ZONING CHANGE REVIEW SHEET

CASE: C14-2010-0015 (The Domain Rezoning-Endeavor) **P. C. DATE:** August 10, 2010

SUBJECT: C14-2010-0015 (Endeavor Domain)

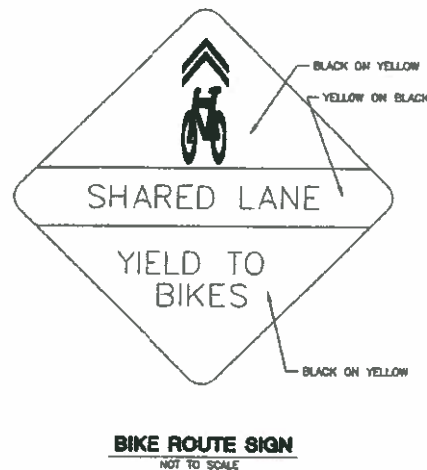
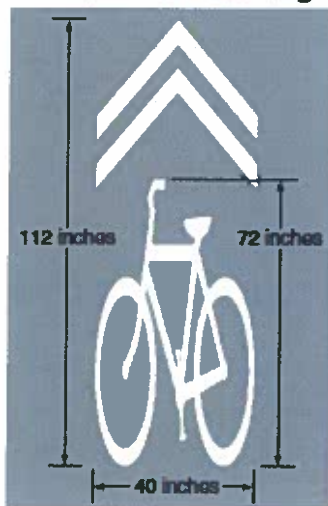
1. Provide bicycle facilities for the project by routing shared lane markings (sharrows) and multi-use (hike and bike) trails through the project as detailed in the attached exhibit, and in compliance with the following standards:

Sharrows

- Shared lane markings shall be installed on roadways shown as sharrow routes on the attached exhibit. The shared lane markings shall be placed with the tip of the chevron in the middle of the lane as measured from face of curb.
- A sharrow facility sign as shown below at a size no smaller than currently installed by Simon on Kramer Ln. shall be placed at least 2 per block (one on each side of the street)
- Angled and head in parking prohibited on either side of roads with required sharrows. Reverse angled parking is acceptable.
- Shared lane markings (sharrows) shall be installed within one year of this agreement on existing roadways and installed at the same time as new roadways are constructed.

Shared Lane Marking

Multi-use (hike and bike) trail

- A minimum 8-foot wide (clear space) off-street multi-use path shall be provided along roadways shown as "hike and bike trail" routes on the attached exhibit.
- Bike route signage shall be provided for the Kramer Lane bike route. The MUTC D11-1 or M1-8 signage is recommended on Kramer Ln.
- Shared use paths shall be provided in conjunction with development of building site plans.
